NO.		DATE	REVISION	APPROV.
158				
<b>HNTB</b> ARCHITECTS ENGINEERS PLANNERS The HNTB Companies				
<b>ARAPAHO ROAD - PHASE III</b>				
SURVEYOR BOULEVARD TO ADDISON ROAD				
ILLUMINATION PLAN				
STA 70+00 TO STA 80+00				
TOWN OF ADDISON, TEXAS				
Design JSN	Drawn GFS	DATE	SCALE	PROJECT NO. SHEET NO.
Check JQH	Check JSN	APRIL 04	1" = 20'	25768 1L-6

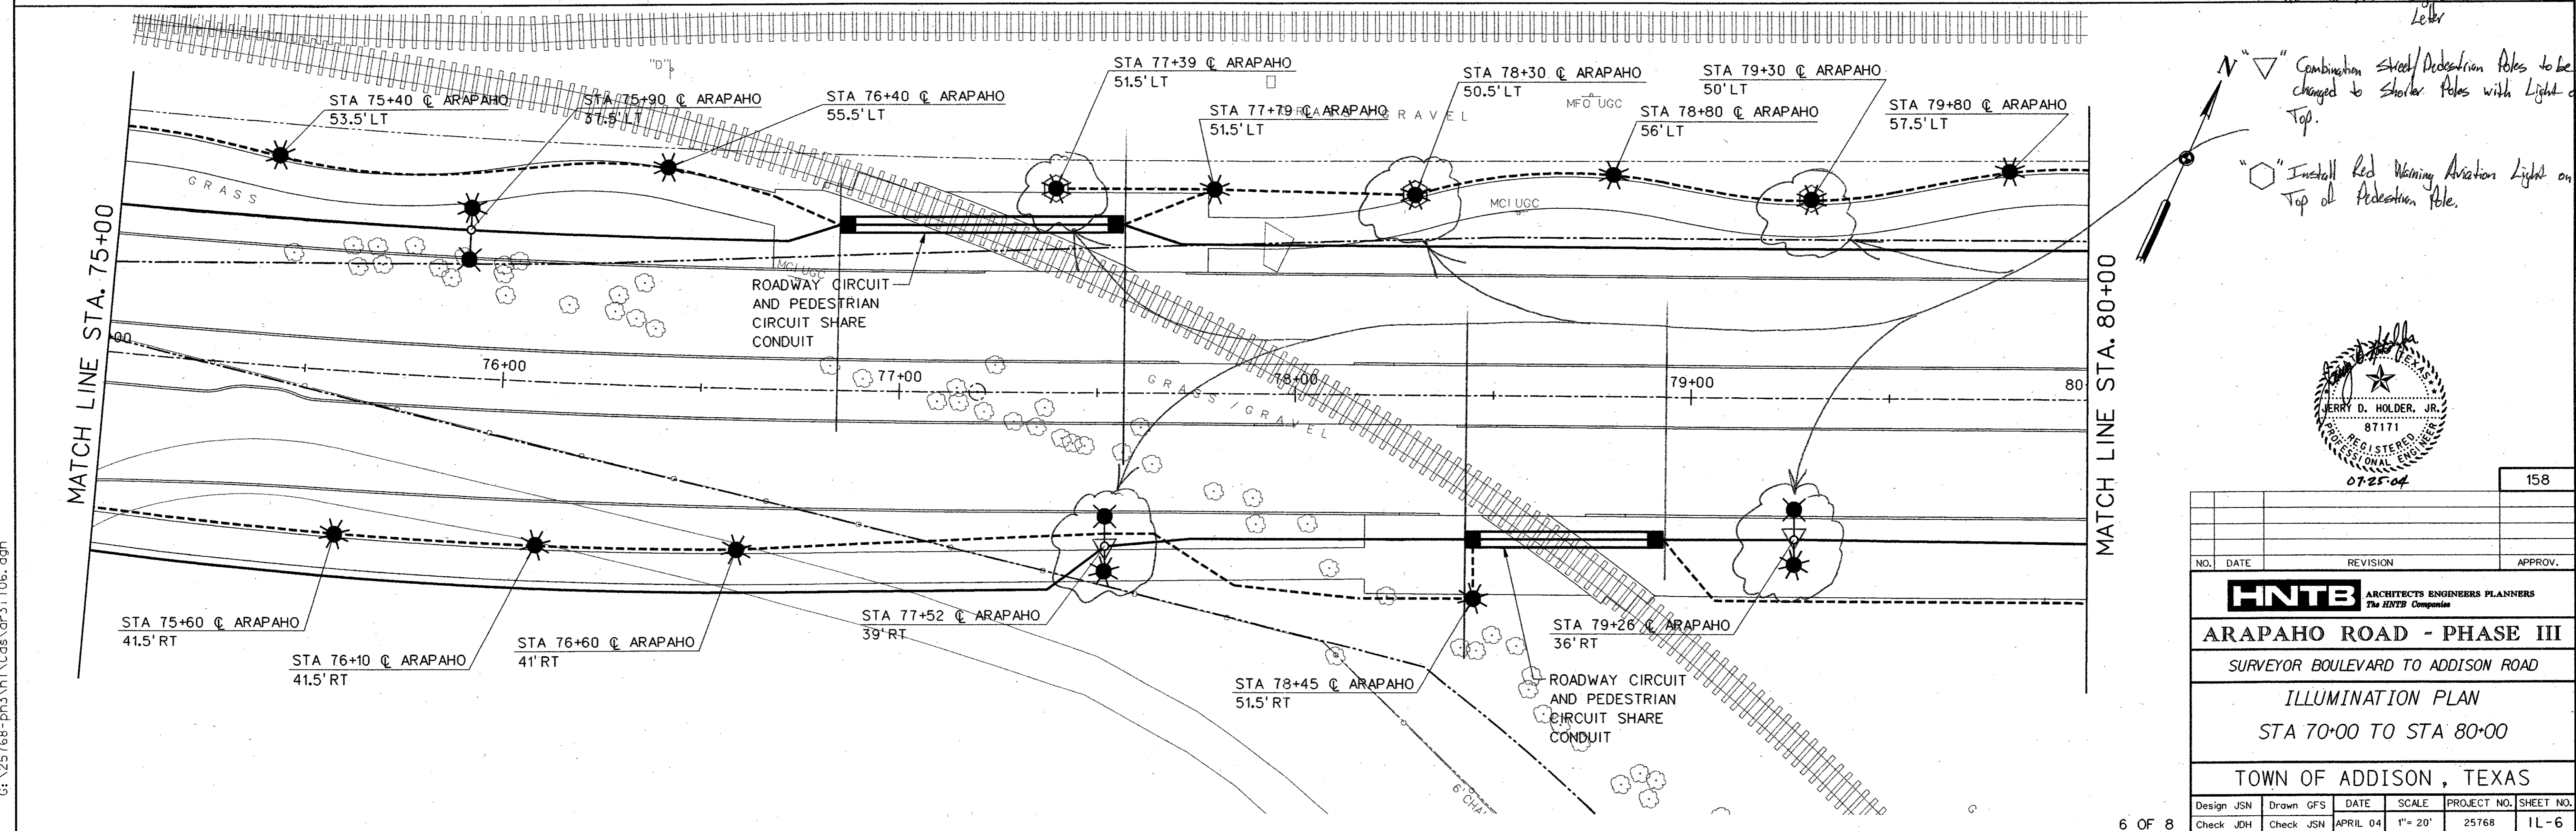
See Additional Aviation Lights At Vertical Obstructions Letter

Combination Street/Pedestrian Poles to be changed to Shoulder Poles with Light on Top.

Install Red Warning Aviation Light on Top of Pedestrian Pole.
